ISC-C1 Rack

Title		
ISC System Wiring Diagram		
Size	Number	Revision
B	D1900511	V10
Date:	8/13/2024	Sheet of 1 37
File:	C:\Users\...ISC_C1_SH1.SchDoc	Drawn By: Filiberto Clara

ISC-R3 Rack

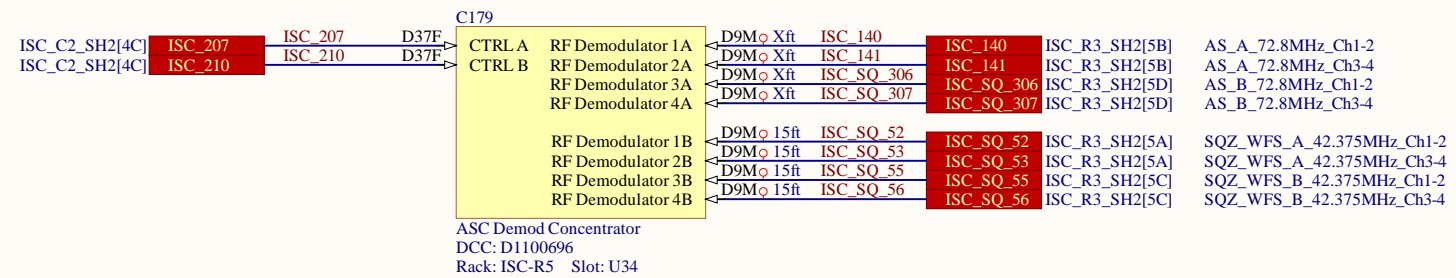
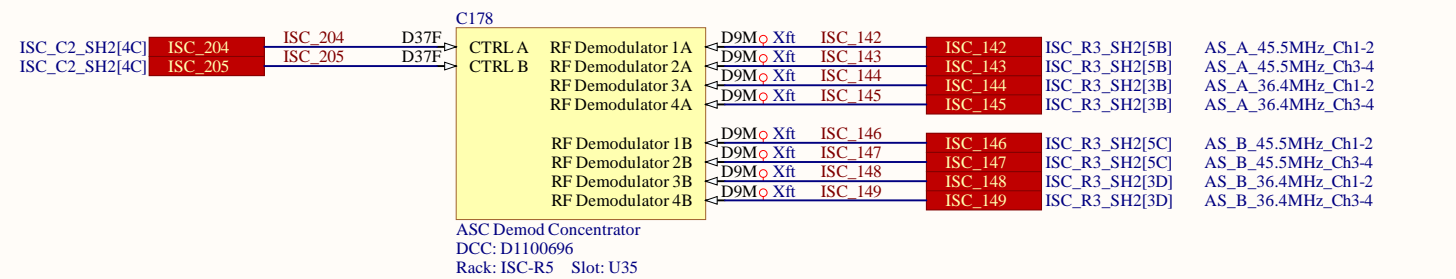
Need to Relabel ISC_R3-RF4

Title		
Squeezer RF Distribution		
Size	Number	Revision
C	D1900511	V10
Date:	8/13/2024	Sheet of 31 37
File:	C:\Users\...SqueezerRfDistribution.SchDpDrawn By: R. Abbott

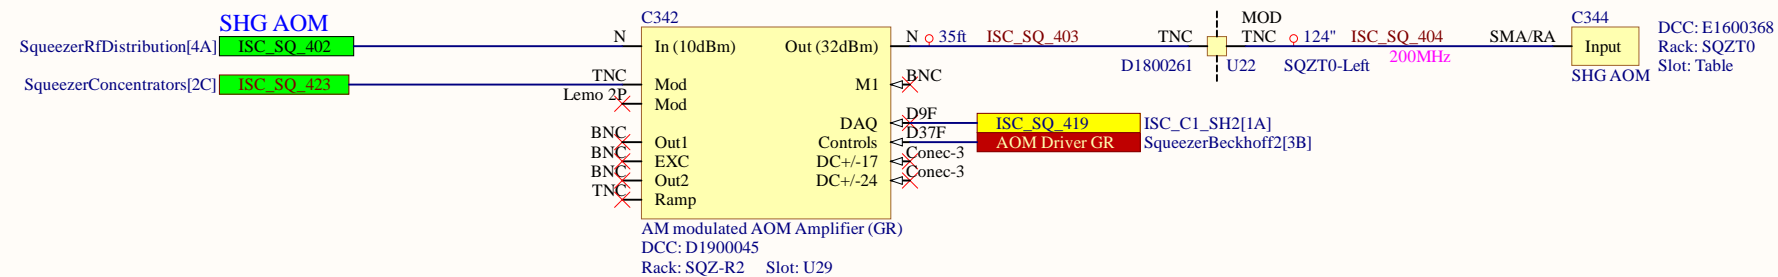
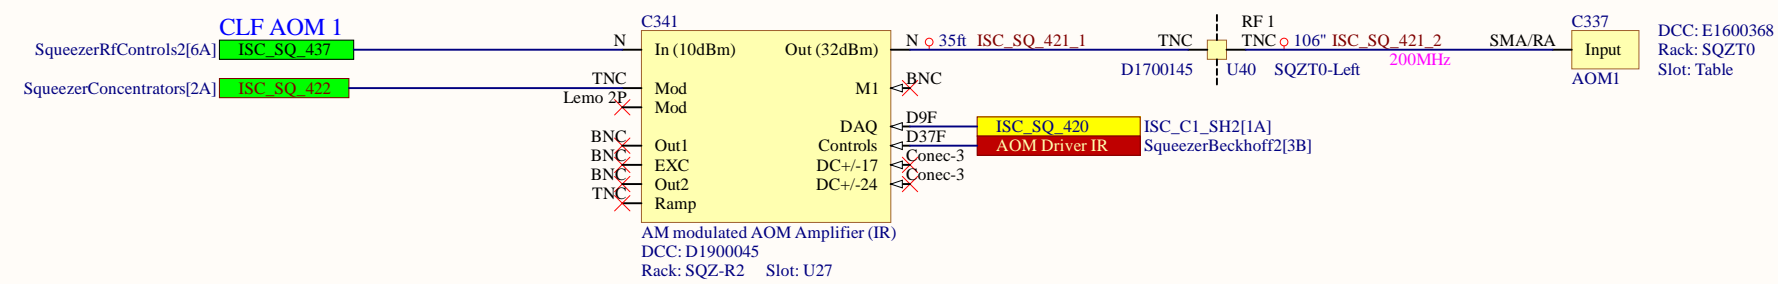
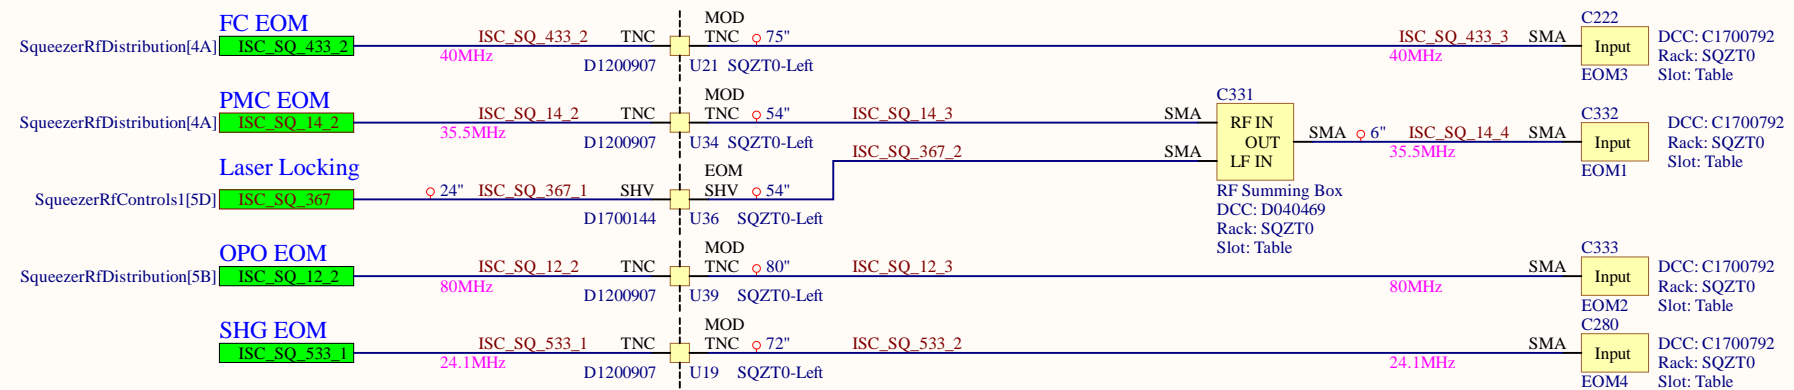
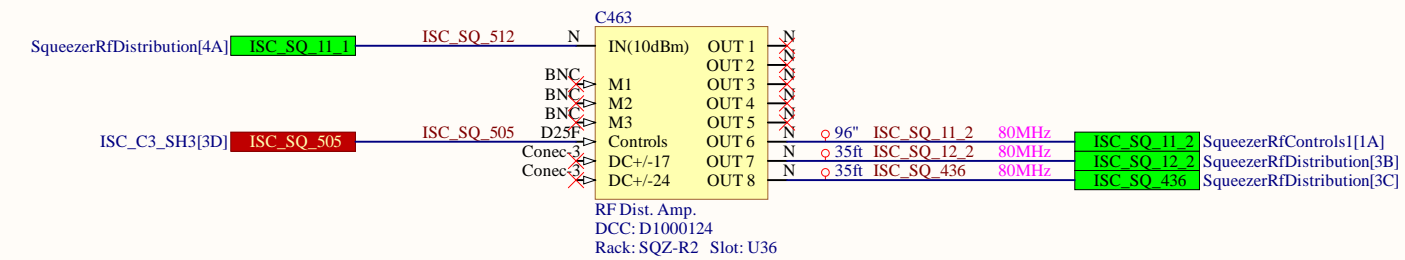
New cables for A_ start at ISC_SQ_430

RF cables carrying the AOM signals need to be 1/4" superflexible helical corrugated coax.
